Addendum No. 1
Screening Equipment Replacement, Capital Project No. 1858

This Addendum No. 1, dated December 7, 2018, to the Invitation to Bid: Screening Equipment Replacement, Capital Project No. 1858, bid opening December 17, 2018 at 10:00 am, supersedes all contrary and conflicting information in the above-mentioned instructions, specifications, and contract documents which are hereby supplemented or revised in certain particulars as follows:

**Screening Equipment Replacement
Capital Project No. 1858
Pre-Bid Meeting – December 3, 2018**

MECHANICAL: LOWER SCREEN ROOM
PLANT WATER SYSTEM

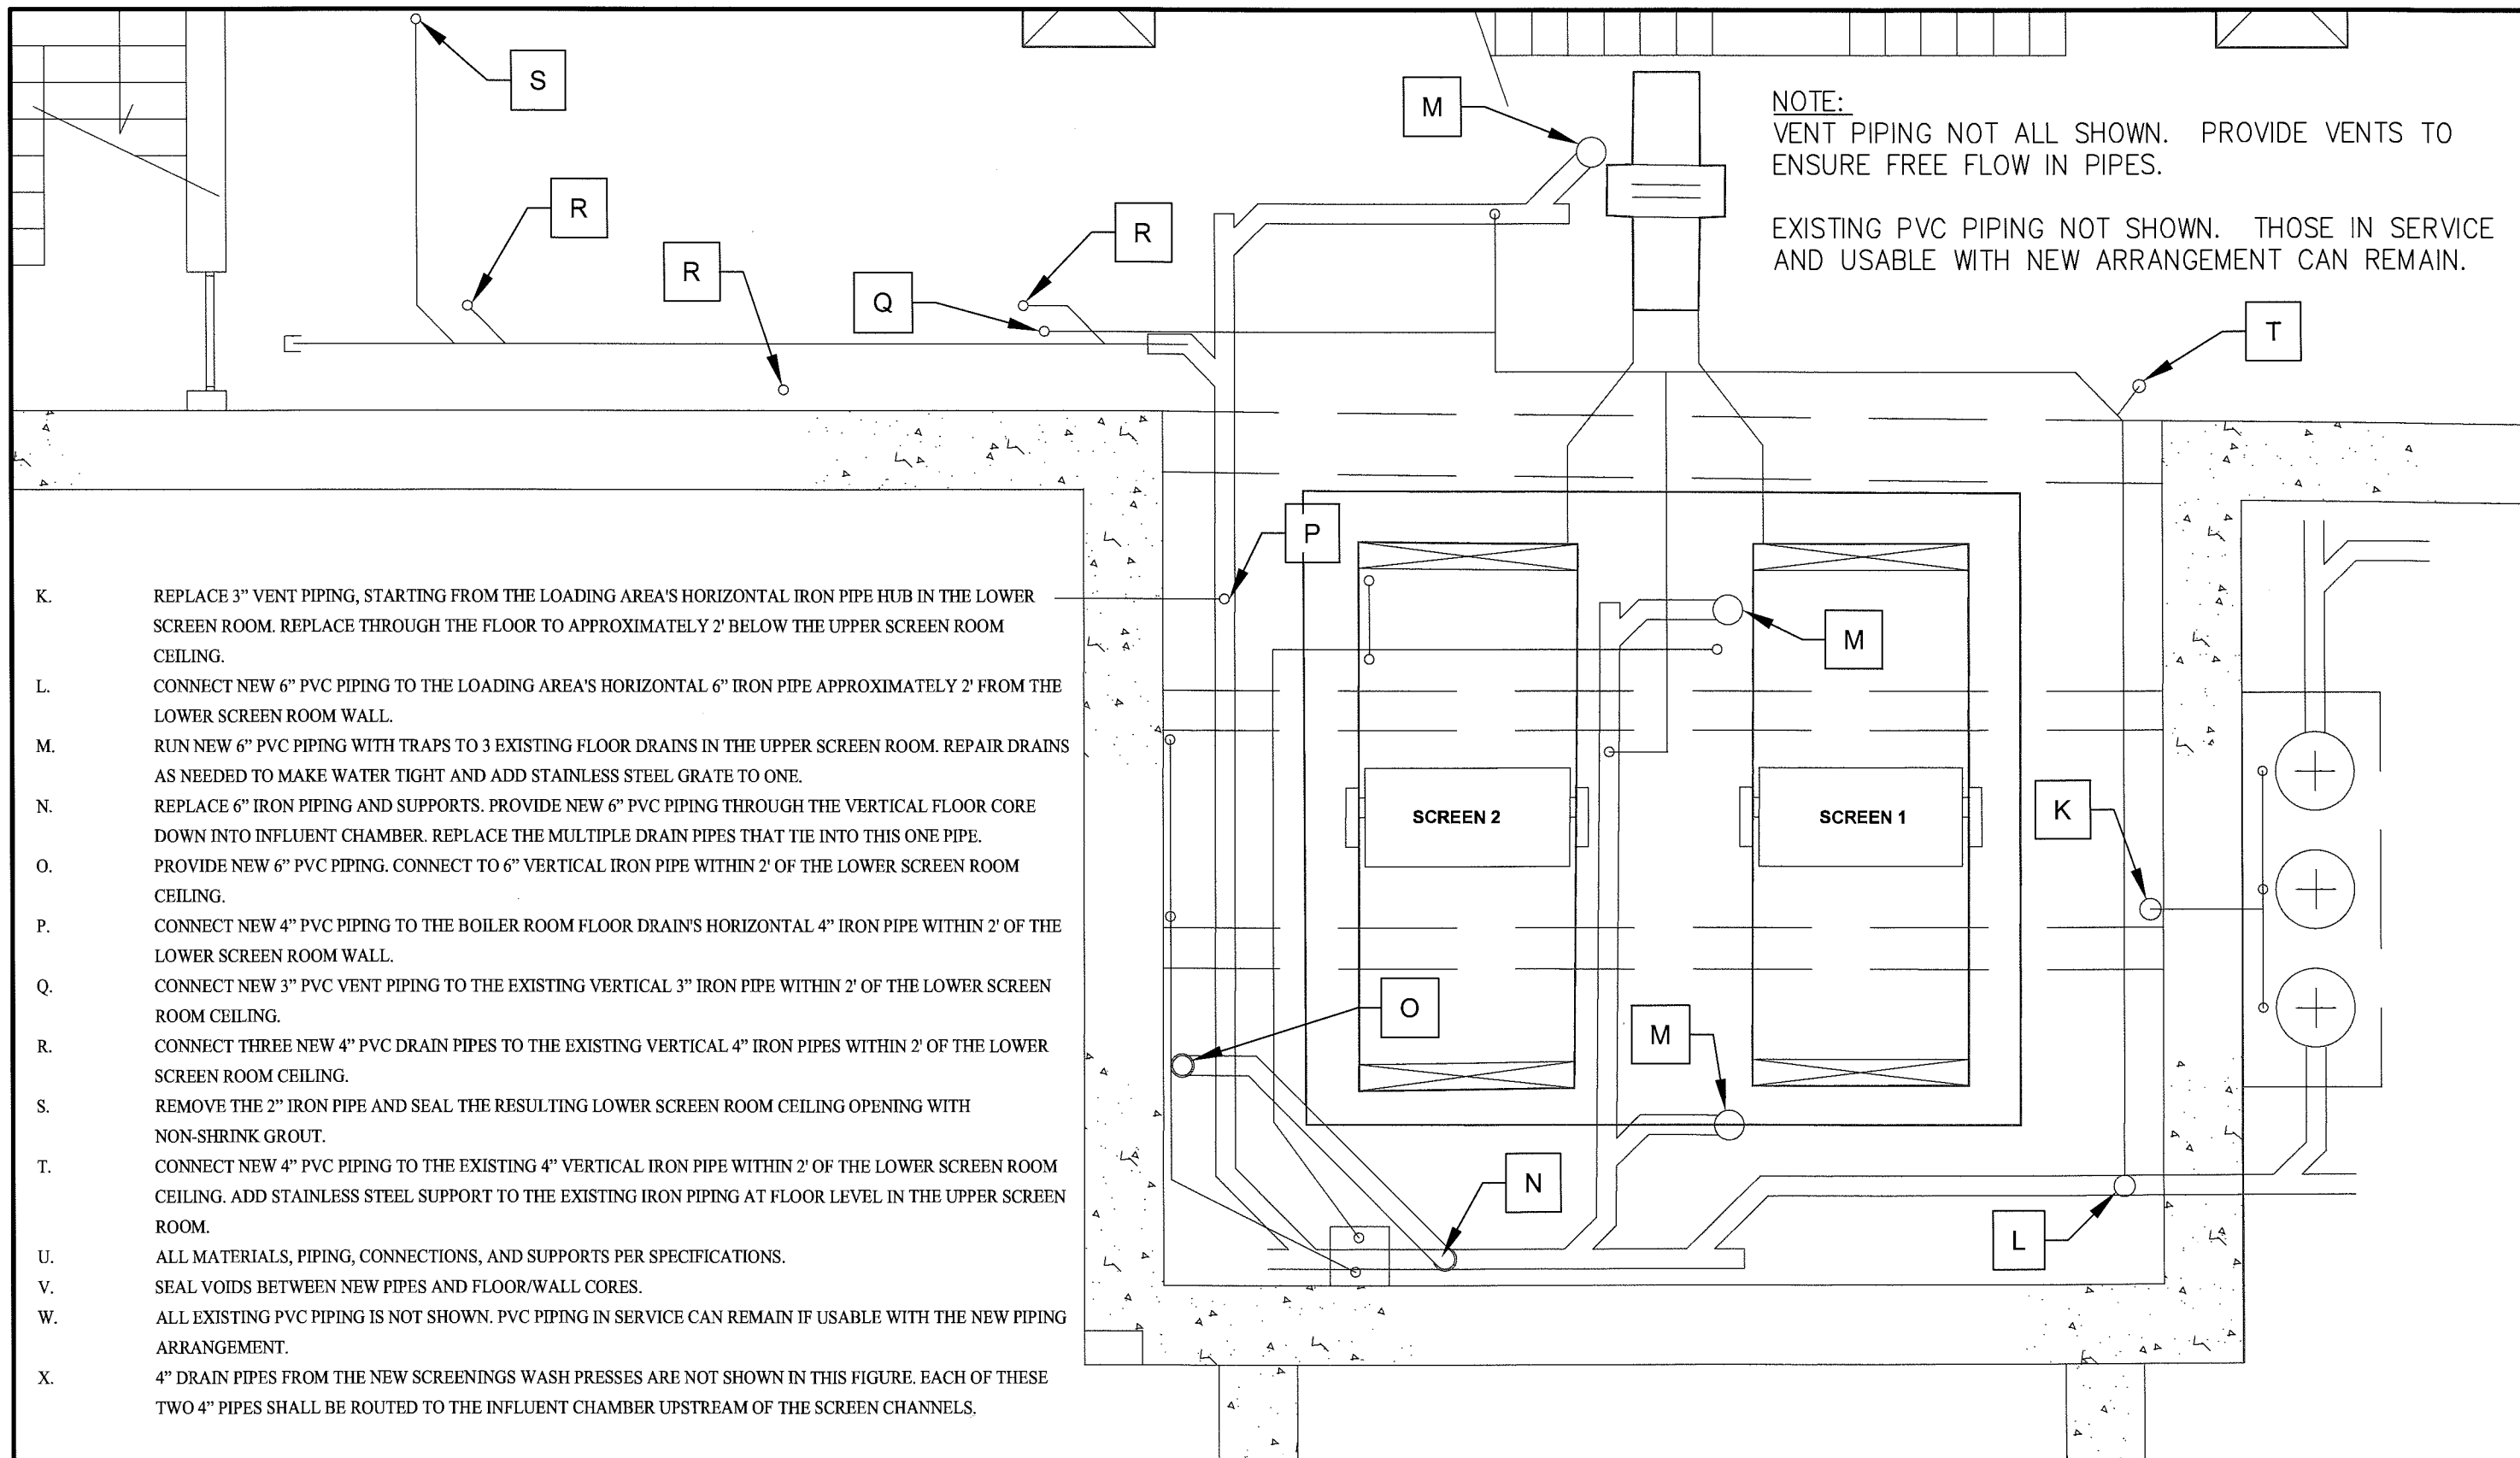
REPLACE PLANT WATER TO AND INCLUDING HOSE BIB IN UPPER SCREEN ROOM. INSTALL NEW HOSE BIB 3' ABOVE THE FLOOR.

REPLACE PLANT WATER TO AND INCLUDING HOSE BIB IN LOADING AREA.

3/4" PVC -CONNECT TO 2" PIPE DOWNSTREAM OF THE BACKFLOW PREVENTER. PROVIDE VALVE ON THE 3/4" PIPE.

4' ABOVE THE FLOOR, CONNECT EXISTING 2" GALVANIZED STEEL TO NEW 2" PVC PIPING.

1. CONNECTION OF NEW PVC TO EXISTING COPPER SHALL USE MALE THREADED ADAPTER ON COPPER PIPE AND FEMALE THREADED ADAPTER ON PVC PIPE AND A UNION ON THE PVC PIPING.
2. ALL WATER PIPES SHALL BE INSULATED AND JACKETED.
3. ADD STAINLESS STEEL SUPPORTS FOR ALL PIPING.
4. ALL VOIDS BETWEEN PIPES AND SLEEVES/CORES SHALL BE SEALED.

MECHANICAL: LOWER SCREEN ROOM
DRAIN AND VENT PIPING

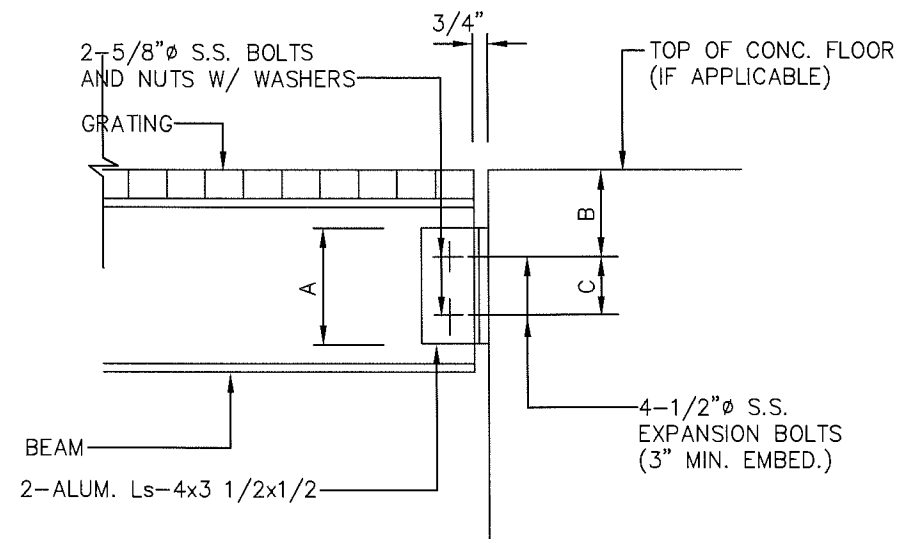
- "8. ALL NEW AND REMAINING CITY WATER PIPING SHALL BE INSULATED.
- 9. SEE CITY WATER PIPING DETAIL IN ADDENDUM 1 FOR NEW CITY WATER PIPING LAYOUT.
- 10. SEE PLANT WATER PIPING DETAIL IN ADDENDUM 1 FOR NEW PLANT WATER PIPING LAYOUT.
- 11. SEE DRAIN AND VENT PIPING DETAIL IN ADDENDUM 1 FOR DRAIN AND VENT PIPING CONNECTION LOCATIONS. NEW PIPING LAYOUT SHALL COLLECT ALL EXISTING AND NEW DRAINS AND VENTS."

GRATING SUPPORT BEAM
CONNECTION DETAIL

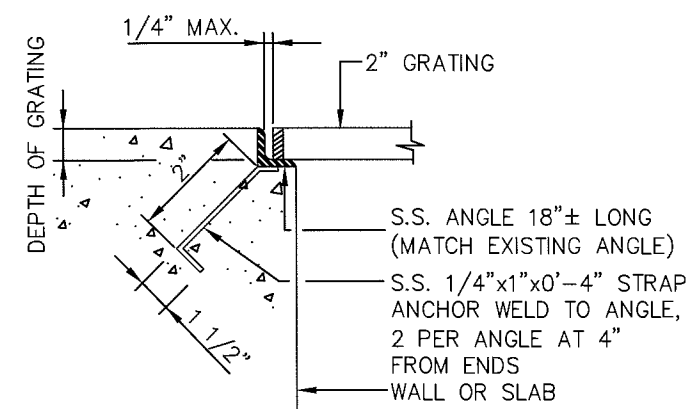
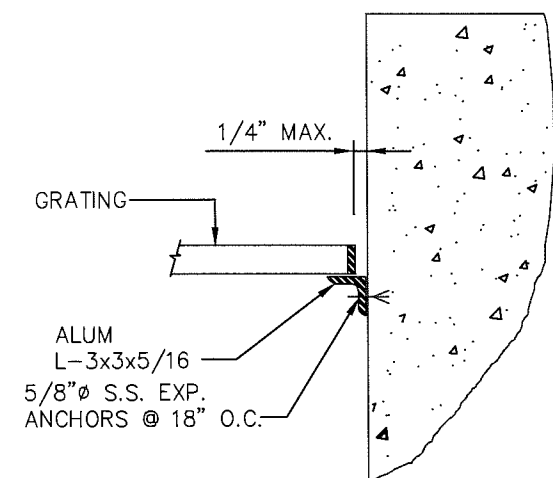
Item 1 of 3, Upper Screen Room add the following note with an arrow pointing to the gap between the screen and the floor: "PROVIDE AND INSTALL REMOVABLE 2" ALUMINUM BORDEN TYPE GRATING TO FILL IN ALL VOIDS LARGER THAN 6" WIDE AT THE SCREENS. ADD SUPPORTS PER GRATING DETAILS SHEET IN ADDENDUM NO. 1."

Item 2 of 3, Lower Screen Room add the following note with an arrow pointing to the gap between the screen influent side and the floor: "PROVIDE AND INSTALL REMOVABLE 2" ALUMINUM BORDEN TYPE GRATINGS TO FILL IN THE VOIDS UPSTREAM OF THE SCREENS. ADD SUPPORTS AS NEEDED PER GRATING DETAILS SHEET IN

ADDENDUM NO. 1. GRATINGS SHALL BE PROVIDED WITH REMOVABLE RESTRAINTS TO PREVENT FLOATATION.”

NOTE: GRATING SHALL BE REMOVABLE.
PROVIDE RETAINING CLIPS TO PREVENT
FLOATING IN THE LOWER SCREEN ROOM.
ANGLES SHALL BE WELDED TO THE EXISTING
ANGLES AND SECURED IN PLACE UNTIL
CONCRETE CURES.
